CBC Columbiana Boiler Company

Re: Response to February 11, 2000 RAI on the Model No. ESP-30X Package

Response to February 11, 2000 RAI on the Model No. ESP-30X Package

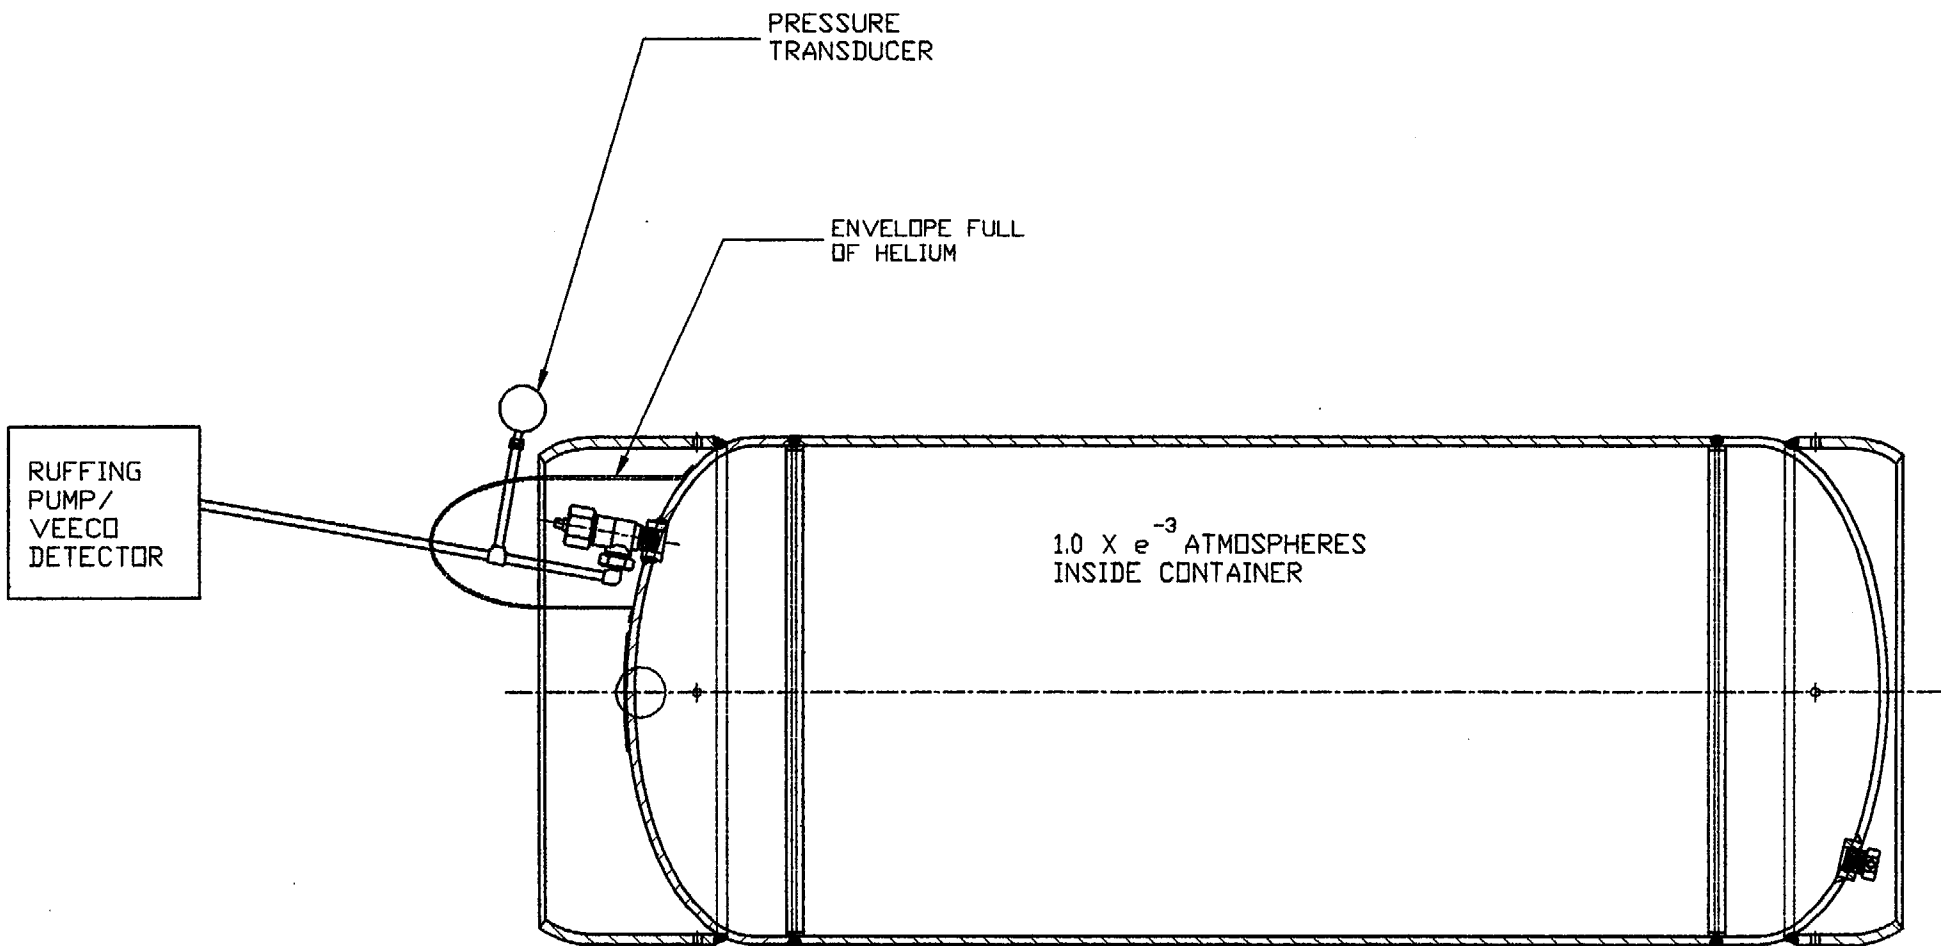
4-3 Explain the change in pressure during the testing of cylinder S/N001 on page 16 of Appendix 2.10.9 including supporting calculations.

Response: After the cylinder had passed the soap bubble leak test and the helium leak test, the cylinder was subjected to a fluorescent dye test. The cylinder was filled with water containing a fluorescent dye and pressurized to 20 psig using shop air. Following pressurization, the cylinder was allowed to sit for a minimum of 8 hours. The pass/fail criteria set for the test was the absence (pass) or presence (fail) of fluorescent dye traces on the exterior surface of the cylinder and valving. No dye was present on the exterior surface or valving of the cylinder tested; therefore, it was concluded that the cylinder and valving did not leak. However, a drop in pressure during the test occurred during the test period. In the opinion of SWRI, this pressure drop was not an indication of leakage for the following reasons:

- 1) The soap bubble test subjected the entire containment boundary to 100 psig and no leakage was detected. It would not have been possible to maintain 100 psig had a leak been present in the cylinder containment boundary or valving.
- 2) The helium leak test subjected the entire containment boundary to an internal pressure of $1.0\text{E-}03$ atm. The vacuum was stabilized and maintained during the helium test procedure. It would not have been possible to stabilize the vacuum if a leak had been present in the cylinder containment boundary or valving.
- 3) No fluorescence was detected on any exterior surface of the cylinder or valving.

There are several possible explanations for the pressure drop that was observed during the fluorescent dye test. The most likely are:

- 1) While internal temperature measurements were not made after the fire test was completed, the content temperature was approximately 20°F higher at the

- initial pressure reading (following the fire test and beginning the fluorescent dye test) than the final pressure reading (following the fluorescent dye test).

- 2) Using the ideal gas law and 20°F differential temperature, the resulting change in pressure would have been 2.5 psig.
 - 3) The initial pressure measurement was made after changing the orientation of the cylinder from vertical to horizontal. The pressure transducer diaphragm may have had water against it during the initial measurement, causing an artificially high reading, due to the water and its temperature. The final measurement was taken many hours later, after the trapped water had an opportunity to drain away and allow the diaphragm to return to ambient temperature. Without knowing the exact temperatures involved it is not possible to calculate the pressure drop that would have occurred due to water; however, because the pressure transducer is highly sensitive to temperature fluctuations, the differential pressure could have been as high as 10 psig.

- 4) Instrumentation drift or failure may have caused an artificially high or low reading. A 1% drift of the transducer's full scale would correspond to 1.5 psig.

The pressure was not being monitored as a quality test, merely as a guide. The presence or absence of the fluorescent dye provided the pass/fail criteria for the test. In order for the cylinder to leak and not produce an exterior fluorescence from the dye, it would have had to leak at the location of an air bubble (estimated half-liter in volume) trapped in the cylinder during the test. Because of the orientation of the cylinder, the air bubble would not have been located at a weld seam. There was no observed damage on the exterior skin of the cylinder that would have indicated a leak at a location other than a weld or valve. Thus, there was no avenue available for leakage from the air pocket, and no water leakage was detected. Therefore, it is the opinion of SWRI that the cylinder did not leak, and that the observed pressure drop was caused by unknown experimental circumstances.
